From: Aled Jones <aled@sustainablestudio.co.uk>
Sent: 21 January 2026 17:38
To: Quinn, Vicky (Senior Planning Officer) <Vicky.Quinn@newport.gov.uk>
Cc: Gabriella Abbott <gabriella@sustainablestudio.co.uk>
Subject: 25/0959 Highways Comments

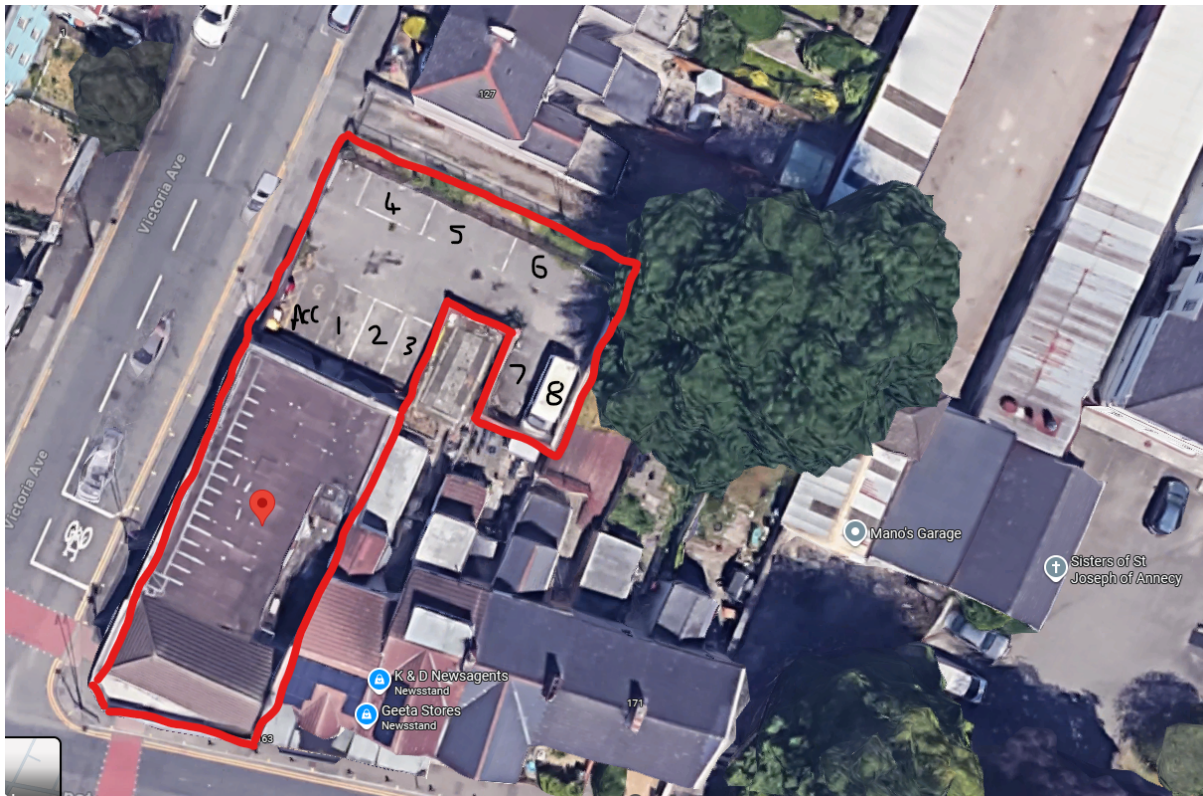
I note Kevin Jackson's comments regarding the lack of gate setback and visibility splay. These features are existing, and the arrangement was explicitly considered and accepted at appeal in 2008 following the Council's refusal of the original application relating to the gates and fencing.

The Google satellite imagery clearly shows the established layout, including the Accessible parking space and eight standard spaces. A commercial van is visible occupying space 8 in the imagery. Spaces 4, 5 and 6 are indeed 4.8m rather than 6m in length, as Kevin notes; however, this is an inherited condition rather than a design decision. While it is technically possible to extend these spaces to 6m, doing so would reduce the available area for bin and cycle storage. The site is finite, and we can only work within the physical constraints that already exist.

The car park is entirely existing and is proposed to be reused in its current form. It has historically served both Barclays Bank and the Funeral Directors effectively. While the layout and turning arrangements are not ideal, these limitations arise from the site's awkward shape and long-established configuration. In practical terms, there are no meaningful alterations that would improve the situation without fundamentally changing the site, which is not feasible.

Regarding waste storage, the car park contains several areas where bins were previously located, all of which can continue to be used. The site is fully enclosed to its boundaries, retaining the high level of secure design associated with its former use as a bank. As a self-contained compound, there is no opportunity to store bins or recycling off the public highway while still allowing access for collection. For this reason, a private waste collection service will be required—consistent with the historic arrangement—allowing waste and recycling to be collected from within the car park during agreed operational hours. There is also sufficient space to accommodate cycle storage (Sheffield hoops) if required.

I have marked up the existing and proposed block plan to indicate suitable areas for bin and cycle storage.
